FINAL DRAINAGE REPORT

SETTLERS RANCH SUBDIVISION FILING NO. 3

April 22, 2024

JPS Project No. 030501
El Paso County PCD File No. SF-24-9

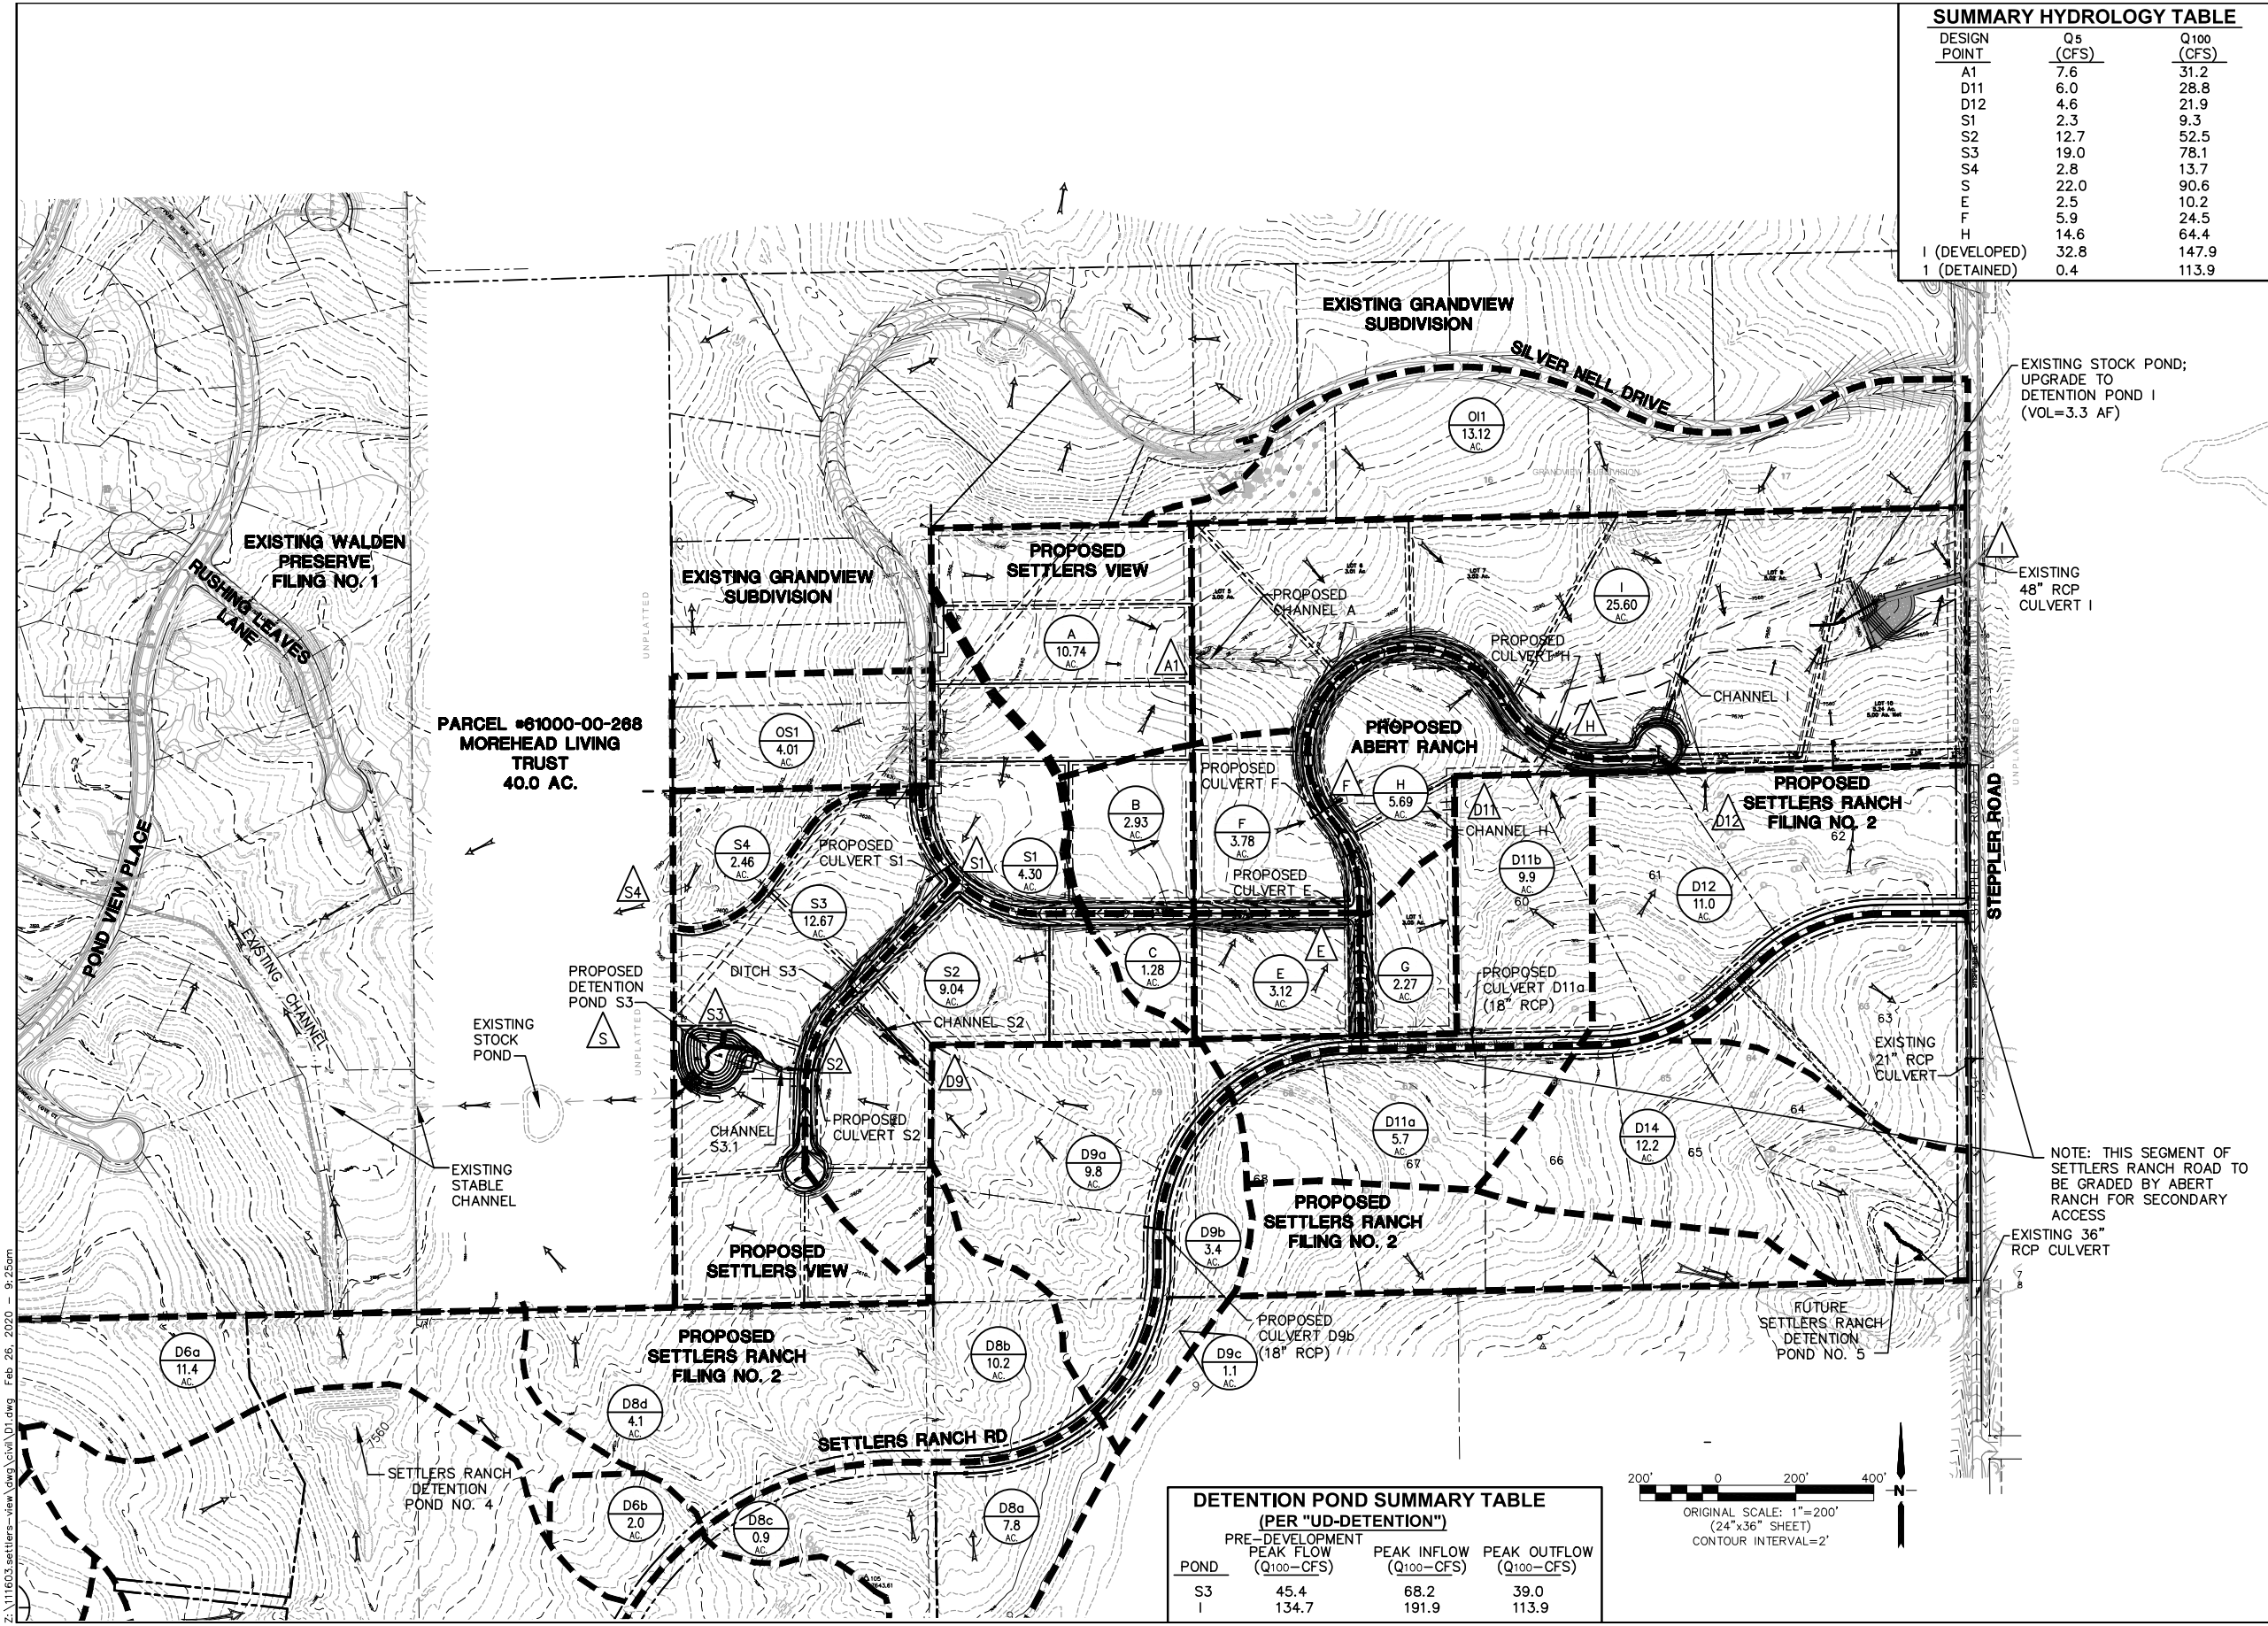
Provide the entire UD-Detention Spreadsheet
